Minute No. 674
Report – Standing Policy Committee on Property and Development – July 8, 2014

Item No. 5 **Secondary Plan – Area Bounded by Gunn Road, Perimeter Highway, Transcona Trail and Central MB Railway (to establish Transcona North Precinct Plan – Precinct "I")**
File SP 6/2013

1. That By-law No. 1/2014, the Transcona North Precinct Plan, be forwarded to Council for second and third reading with the following alterations:

Appendix 'B' – Item 1

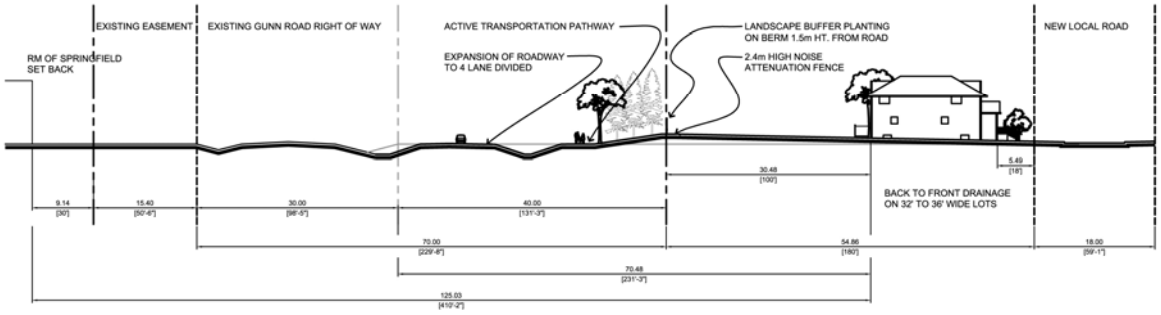
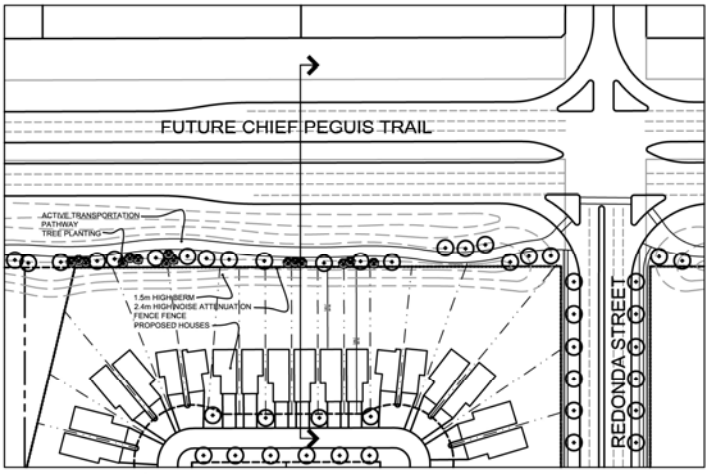
P. That the image included as 'Item 1' of Appendix 'B' be added under section 5.6.3.3(a) and labelled 'Figure 6a: Chief Peguis Trail Expressway Sign'.

"(a) The principal land developer in Precinct I, North Grassie Properties Inc., shall install two 8 foot x 8 foot signs at the far east and far west ends of the proposed development area within the Gunn Road ROW identifying Gunn Road as the Future Extension of the Chief Peguis Trail Expressway as stipulated in the City of Winnipeg Transportation Master Plan. These signs are subject to the approval of the East Kildonan-Transcona Community Committee and shall be installed upon commencement of construction and maintained by the Developer until full build out of the residential development. Figure 6a illustrates the draft Chief Peguis Trail Expressway Sign."

Appendix 'B' – Item 2

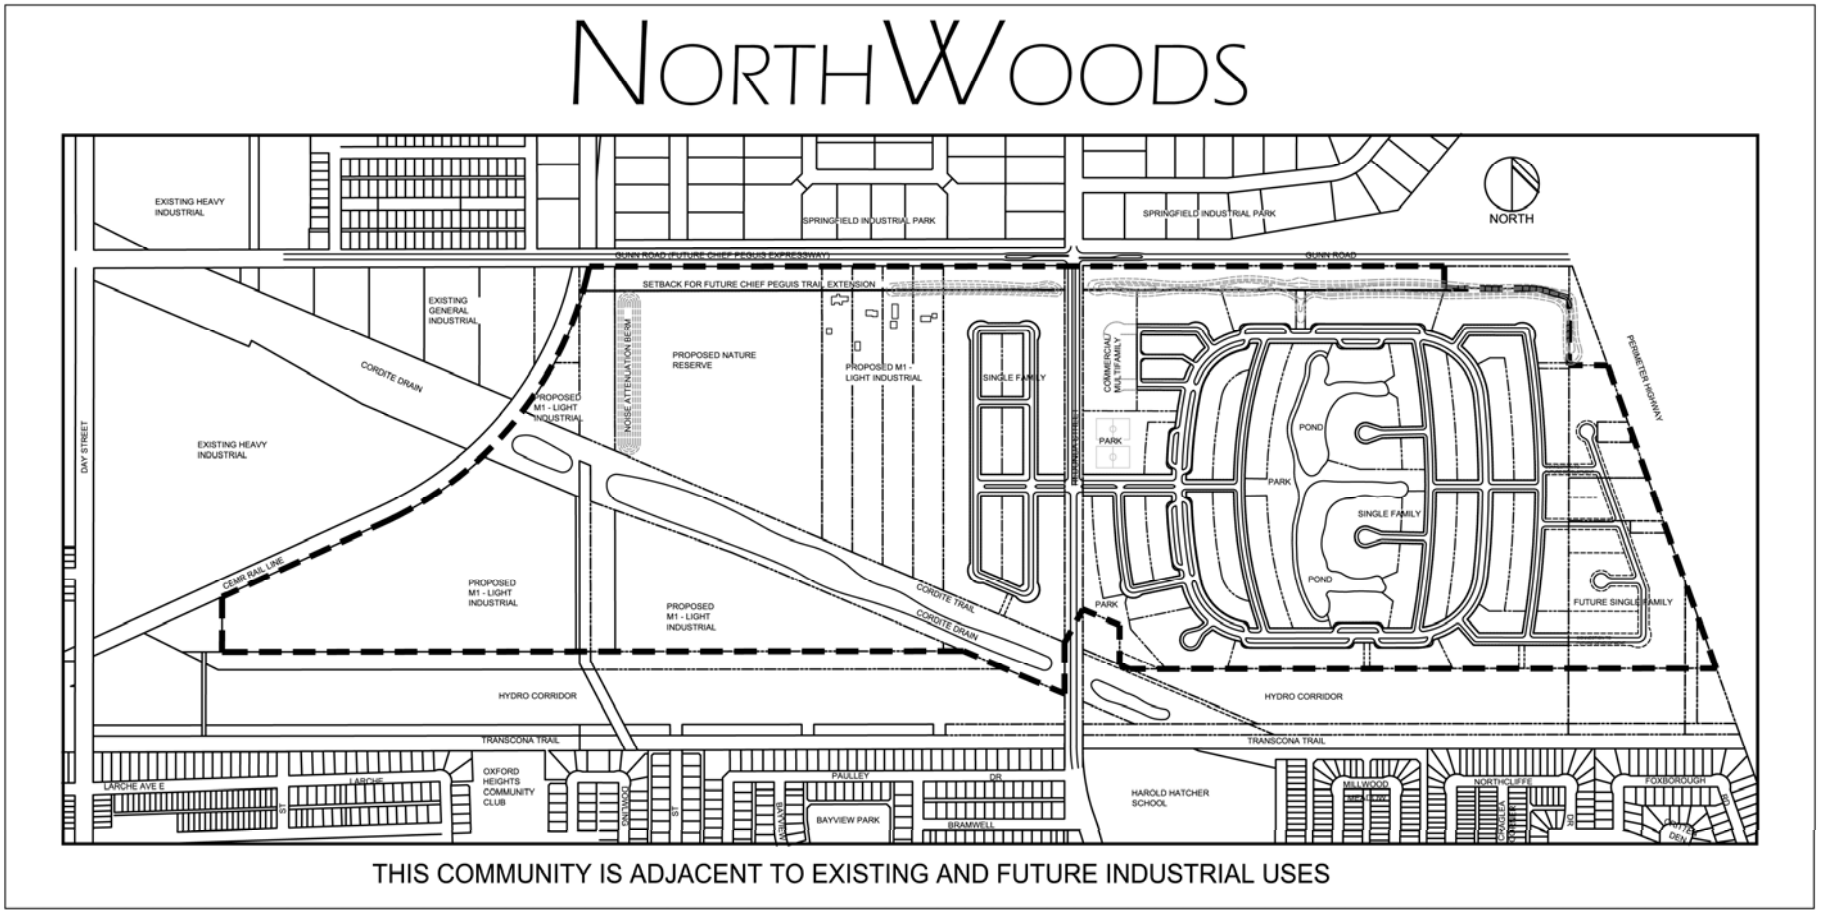
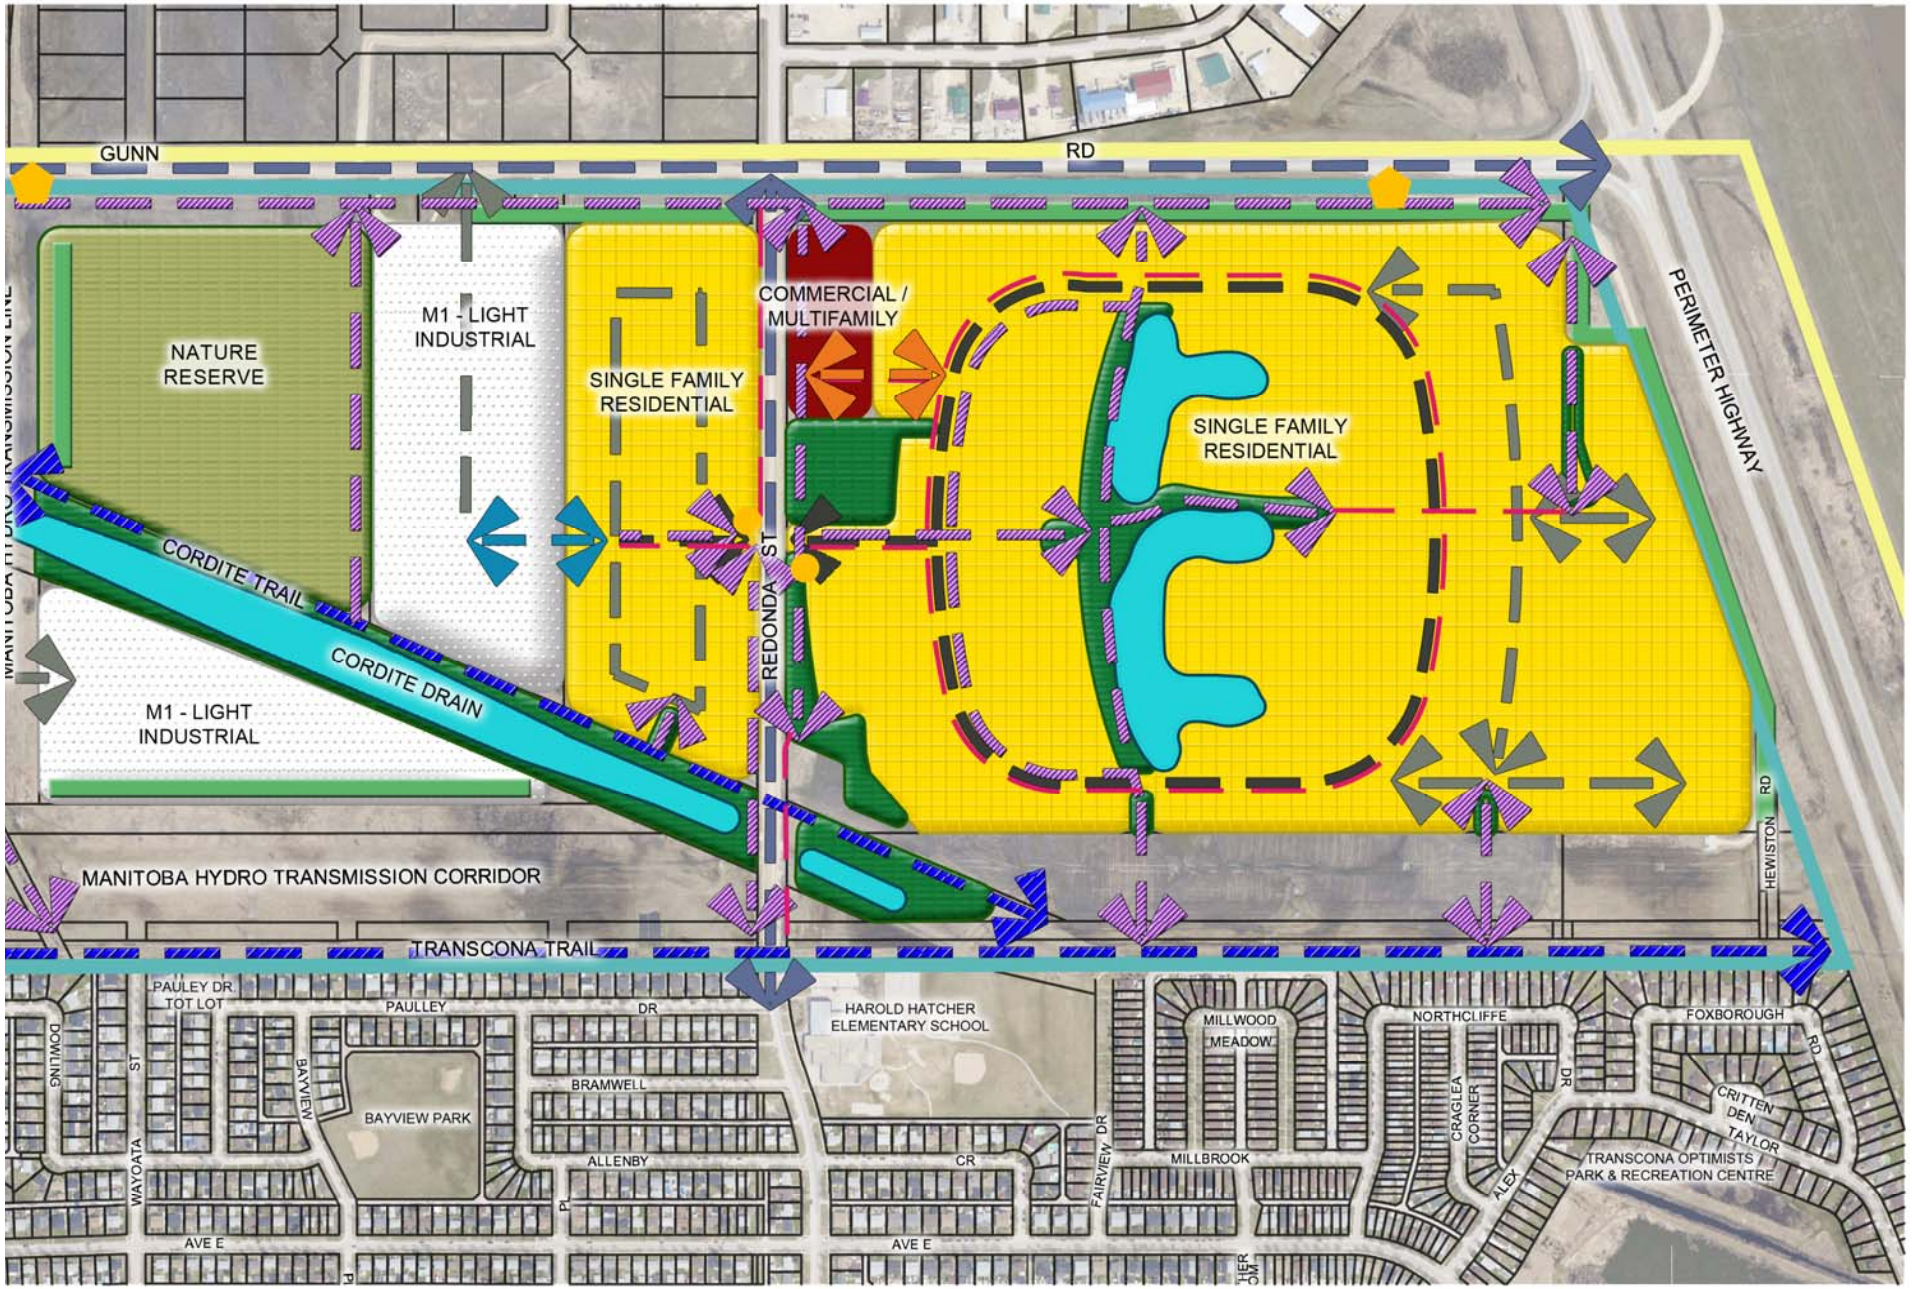
Q. That the image included as 'Item 2' of Appendix 'B' be added under section 5.6.3.3(b) and labelled 'Figure 6b: North Woods Development Sign'.

"(b) The principal land developer in Precinct I, North Grassie Properties Inc., shall install two 4 foot x 6 foot signs, one at each entrance to the Residential Areas on the east and west sides of Redonda, illustrating the plan of the development and the existing adjacent Heavy Industrial Areas to the north and west of the planned development, labelling all existing and proposed land uses with equal prominence. These signs are subject to the approval of the East Kildonan-Transcona Community Committee and shall be installed upon commencement of construction and maintained by the Developer until full build out of the residential development. Figure 6b illustrates the draft North Woods Development Sign."

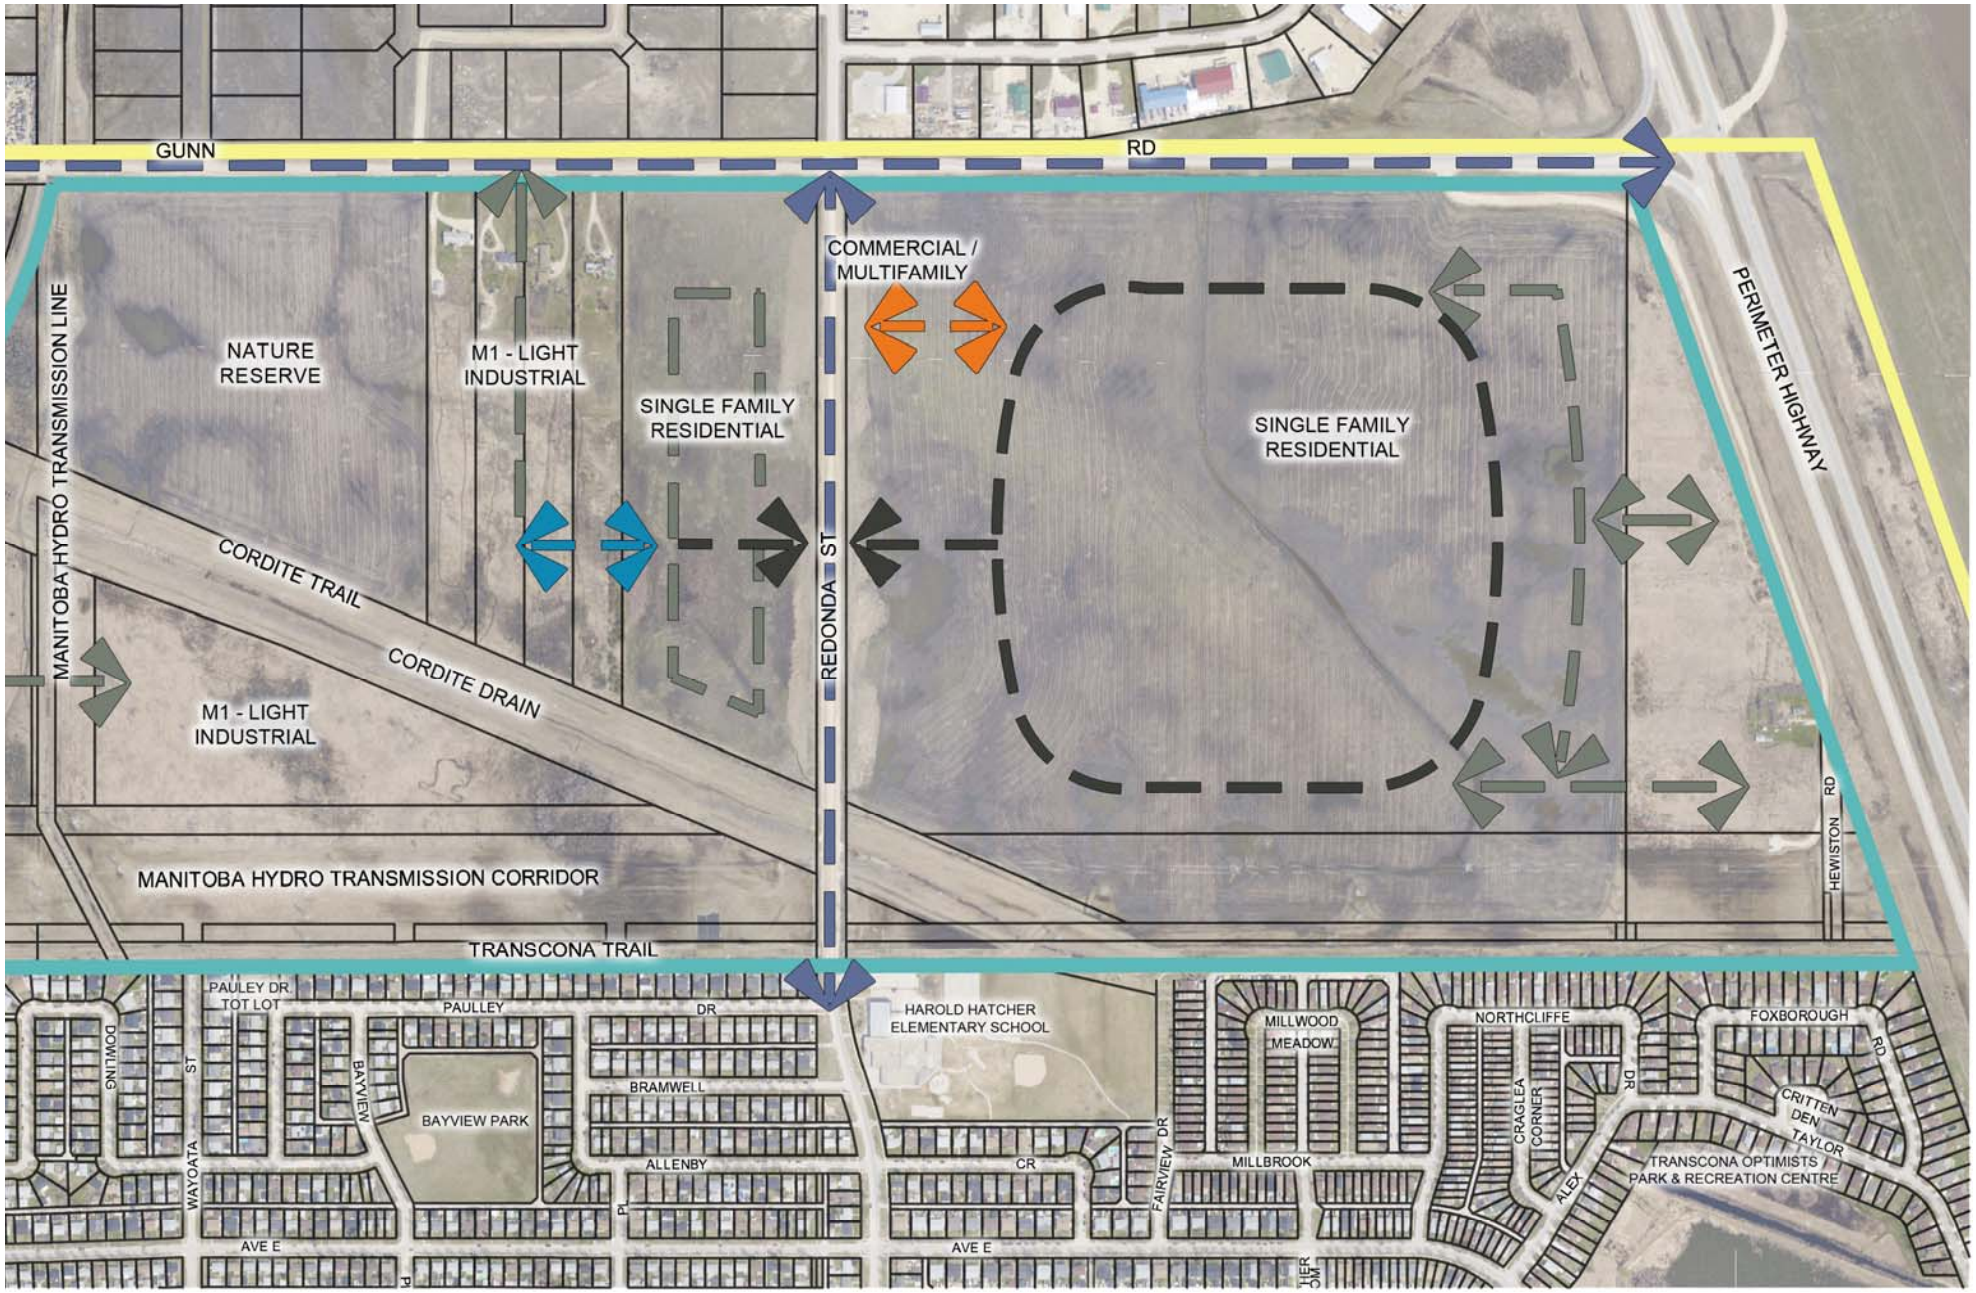
O. That Figure 3: 'Land Use Concept' be replaced with the map included as 'Item 3' in Appendix 'B'.

"Transcona North will be provided with a 1,219 metre (4,000 foot) Restricted Development Zone, indicated on Figure 3 as Proposed Light Industrial Area and Nature Reserve Open Space, within which no new residential development is permitted."

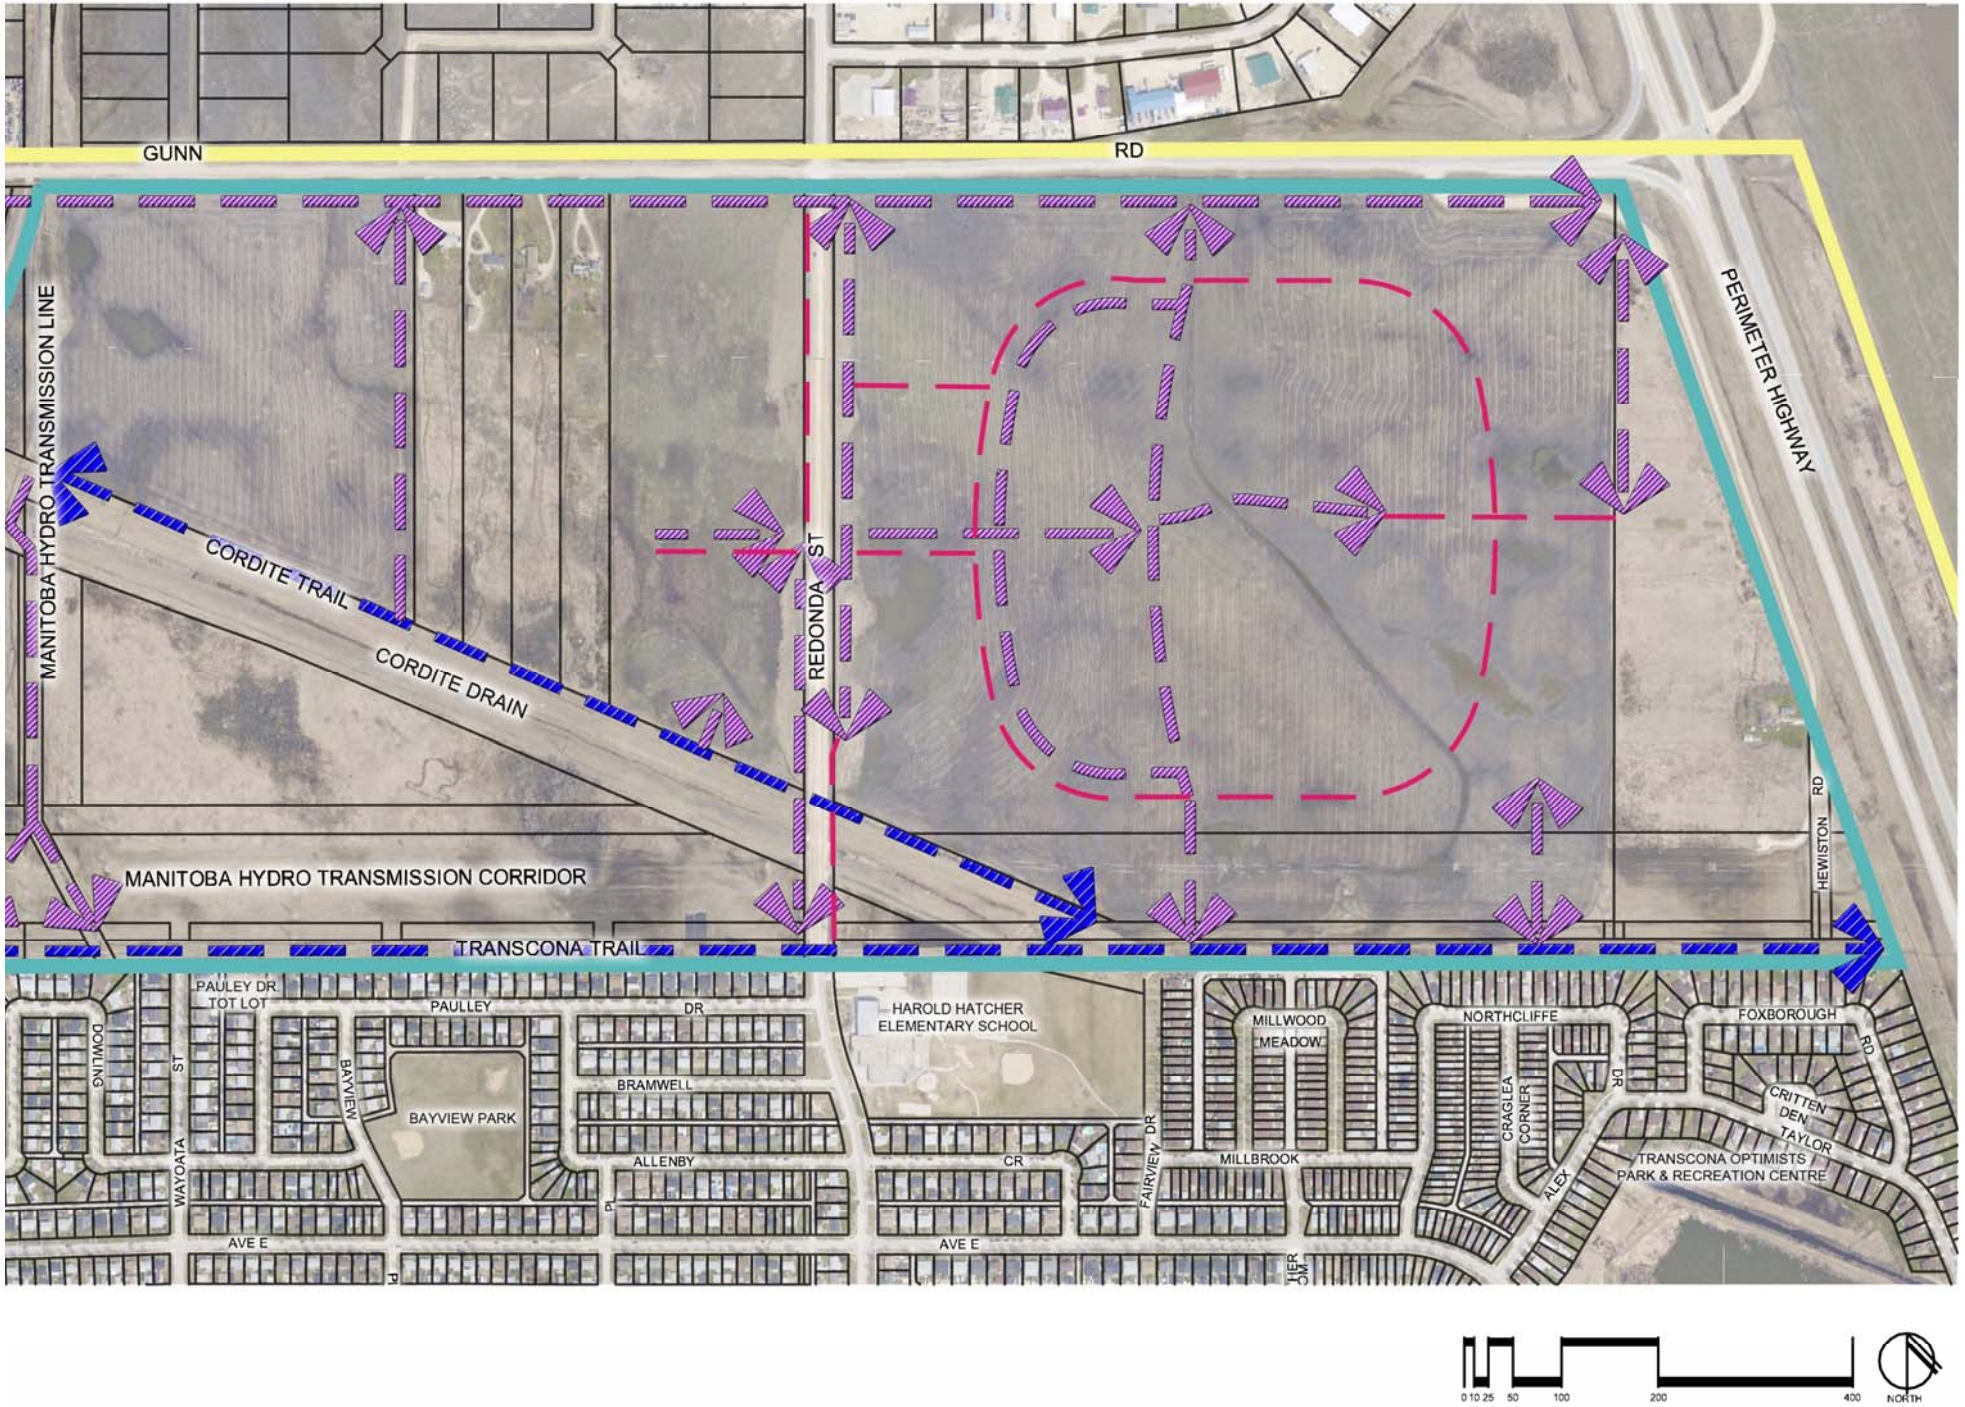
M. That Figure 6: 'Road Network' be replaced with the map included as 'Item 5' in Appendix 'B' and renumbered to Figure 7 and that all text references to Figure 6 be altered to Figure 7 accordingly.
